From: Brian Swope [mailto:Brian@tamparroofing.com]
Sent: Friday, May 29, 2020 8:15 AM
To: Madani, Mo
Subject: Questions for DS 2020-022

7200 NW 2ND AVENUE
BOCA RATON, FL 33487

Claim Number: 4-3839_Building10
Requested: 09/13/2018
Date of Loss: 09/10/2017

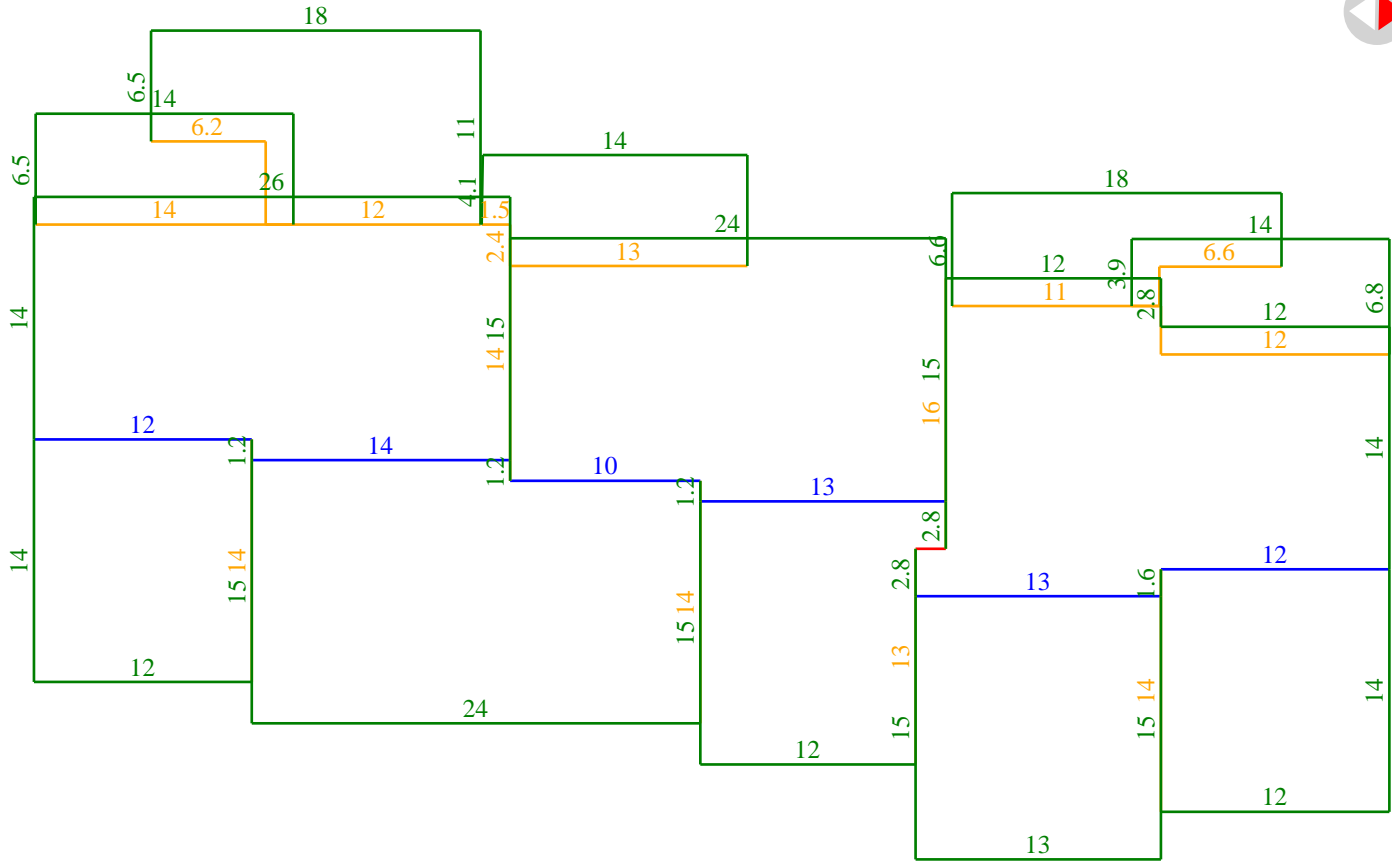
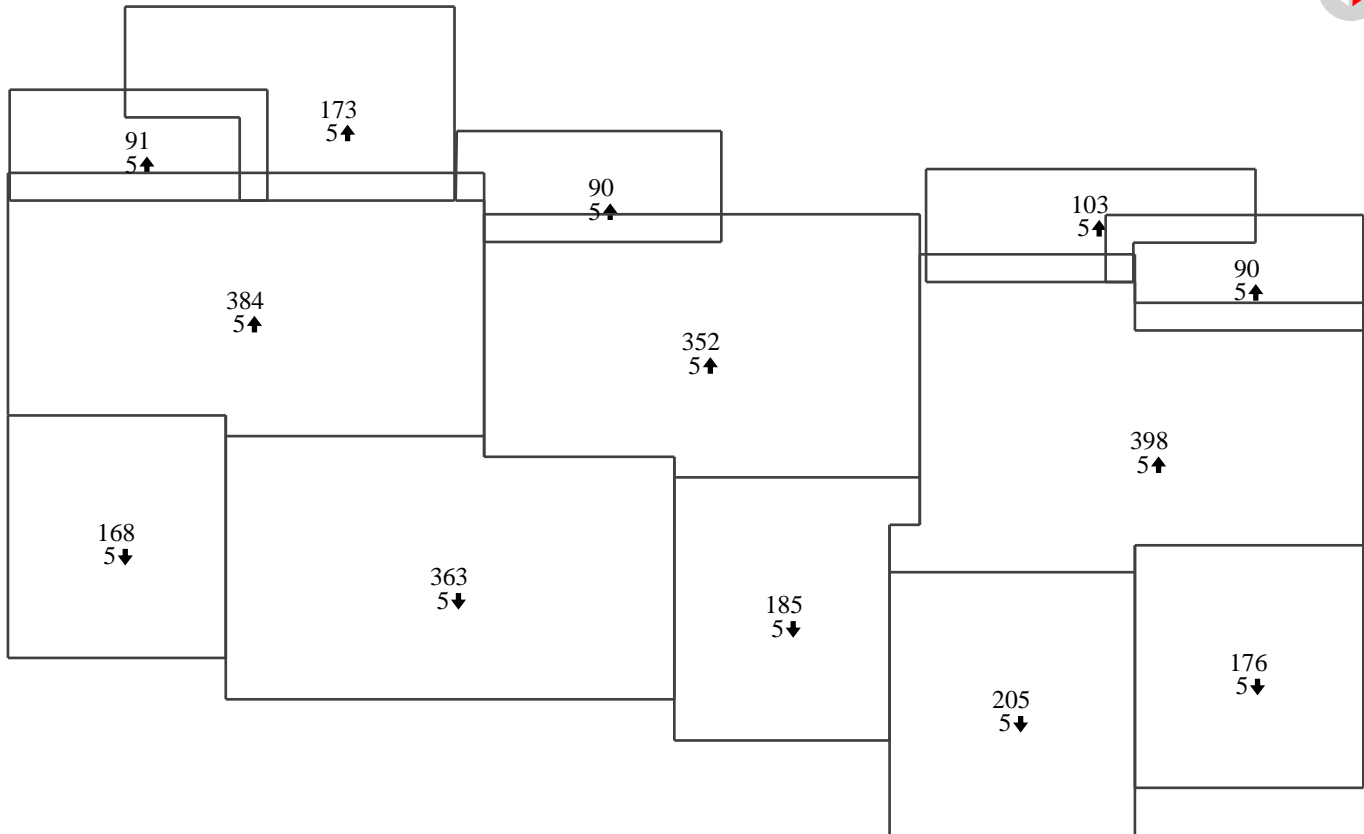
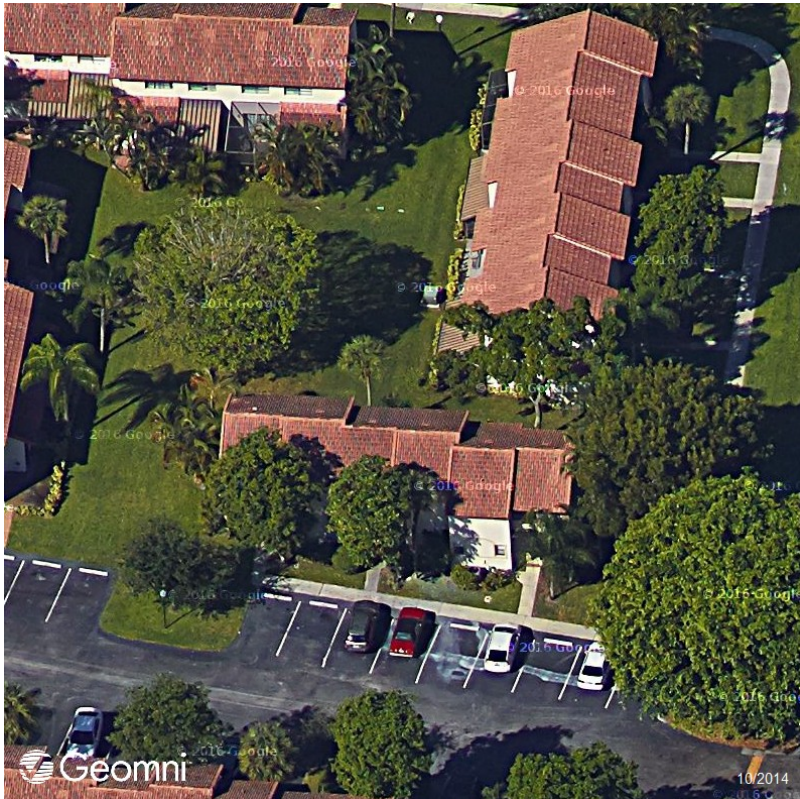
5. Is there any sort of real-time aerial imaging of the building?

We are relying very heavily on the petitioner's information and the sketched drawing with no real verification.

ANSWER: The petitioner, a P.E., A State Certified CCC 1329026 since 2006, doesn't not **arbitrarily** assigns "sections", but rather has first-hand knowledge based upon first hand inspection of said roof (EagleView attached).
